UNITED STATES PATENT AND TRADEMARK OFFICE

APPLICATION NO.	FILING DATE	FIRST NAMED INVENTOR	ATTORNEY DOCKET NO.	CONFIRMATION NO.
10/531,304	04/14/2005	Shigeaki Ueda	017.0001	6429
29453 7590 08/17/2007 JUDGE & MURAKAMI IP ASSOCIATES DOJIMIA BUILDING, 7TH FLOOR 6-8 NISHITEMMA 2-CHOME, KITA-KU OSAKA-SHI, 530-0047 JAPAN			EXAMINER PICKETT, JOHN G	
			ART UNIT 3728	PAPER NUMBER
			MAIL DATE 08/17/2007	DELIVERY MODE PAPER

Office Action Summary

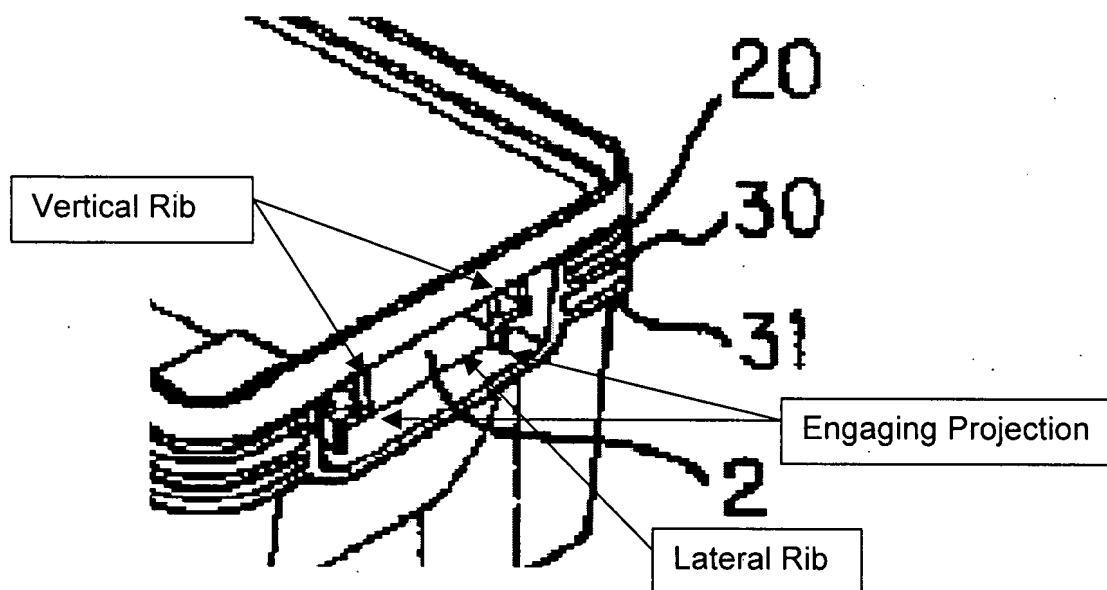
Claim 1: Ohori discloses a container comprising a container body 1, a container lid 2, a cassette 3, a cassette lid 8, an L-shaped flange 10, a first flange 20, and a second flange 30. Ohori further discloses a D-zone (portion with locking part 2), the D-

zone having a lateral rib and two engaging projections provided on interconnecting vertical ribs (see below).

Ohori functions as claimed. Ohori lacks, or does not expressly disclose, vertical ribs between the first and second flanges, the specific distance between the first and second flanges, or the recessed D-zone.
